# Access Compliance Report

## Public Rights-of-Way (Curb Ramps)

Intersection ID: 50041	Main Street: METROPOLITAN_AV	Cross Street: CHARLOTTETOWNE_AV	Location: SE
ADA ID: 1B891A3D0887	Ramp Type: Directional1	Initial Pass/Fail: Fail	Overall Compliance: No
			Severity Score: 13.75

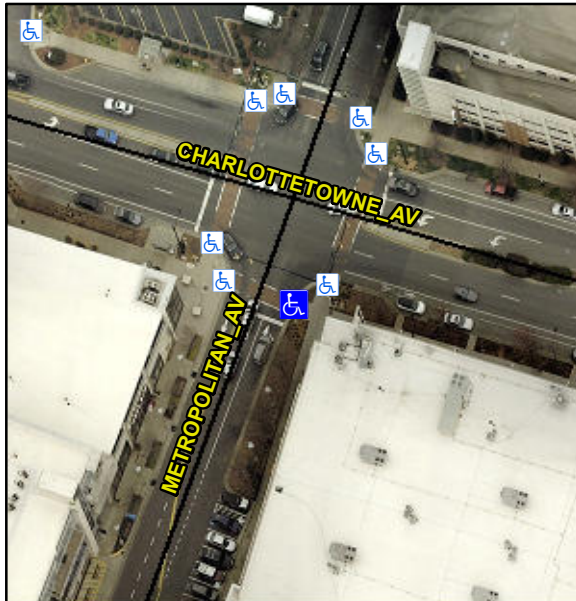
**XWALK PAVERS**

**R304.2.2, R304.5.3**

Compliance	Description	Data	Compliance	Description	Data
N/A	Ramp Length (in)	92.5	N/A	Grade Break?	N/A
Yes	Ramp Width (in)	95.0	N/A	Grade Break Slope (%)	0.0
No	Ramp Slope (%)	8.9	N/A	Grade Break XSlope (%)	0.0
No	Ramp XSlope (%)	3.1			
N/A	Flare Type LT	N/A	N/A	Flare Type RT	N/A
N/A	Flare Slope LT (%)	N/A	N/A	Flare Slope RT (%)	0.0
N/A	Flare Traversable LT?	N/A	N/A	Flare Traversable RT?	N/A
N/A	Landing Length (in)	0.0	N/A	DWS Provided?	N/A
N/A	Landing Width (in)	0.0	N/A	DWS Contrast?	N/A
N/A	Landing Slope (%)	0.0	N/A	DWS Length (in)	N/A
N/A	Landing X Slope (%)	0.0	N/A	DWS Full Width?	N/A
N/A	Landing Curb? (Y/N)	N/A	N/A	DWS Offset LT (in)	N/A
N/A	Shared Landing?	N/A	N/A	DWS Offset RT (in)	N/A
N/A	Gutter Ponding?	0.0	N/A	Gutter Slope (%)	N/A
N/A	Gutter Lip Ht (in)	0.0	N/A	Gutter X Slope (%)	N/A
N/A	Painted X Walk1?	Yes		Road Slope (%)	1.6
	X Walk 1 Direction	To NW		Road X Slope (%)	0.9
	X Walk 1 Width (in)	98.0		Clear Space?	N/A

X Walk 1 Slope (%)	1.6	N/A	Clear Space to XWalk (in)	N/A
	X Walk 1 X Slope (%)	0.9	N/A	Storm Grate/Utility Hazard?	N/A
N/A	Ramp inside XWalk1?	Yes		Storm Grate/Utility Type	
N/A	Any Obstructions?	N/A			N/A
	Obstruction Type		Yes	Surface Condition? (G/P)	Good
			N/A	Curb Slope (%)	7.2

**Remove & Replace Entire Ramp.**
